Please find attached a submission with regard to DA2023/1548 - 3 Waratah Road, Palm Beach

**RE: DEVELOPMENT APPLICATION DA (DA2023/1548)
ALTERATIONS AND ADDITIONS TO A DWELLING HOUSE AND ASSOCIATED WORKS.
3 WARATAH ROAD, PALM BEACH**

I write in response to the development application lodged for 3 Waratah Road on behalf of the owners of 5 Waratah Road. My client's property is to the south of the subject site and raises concerns with the proposed works to the garage with studio space above.

Image 3: Potential amendments

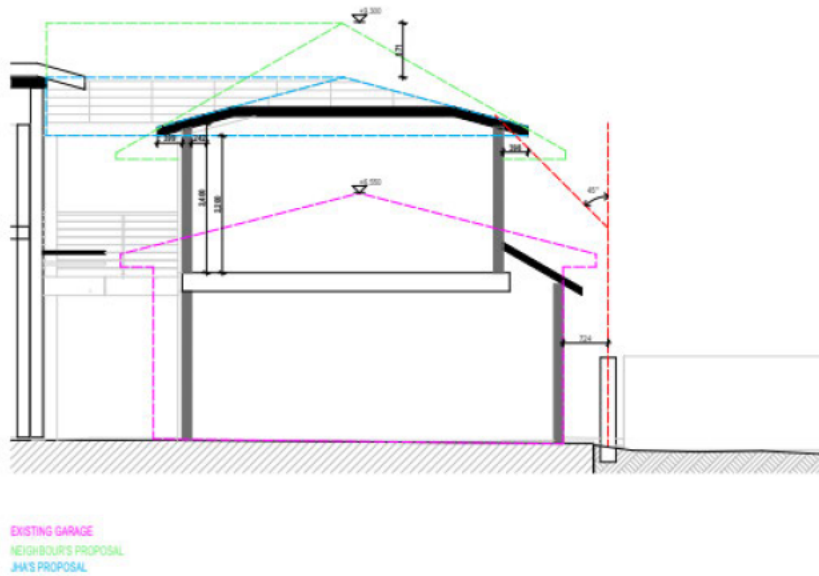
Should the studio above the be supported by Council we request that the bathroom be deleted to ensure it is not used for separate habitation. We also seek a redesign to minimise its bulk and scale which include lowering the height and pitch of the roof which would match the existing pitch and ridge RL's. An indicative drawing is provided below:
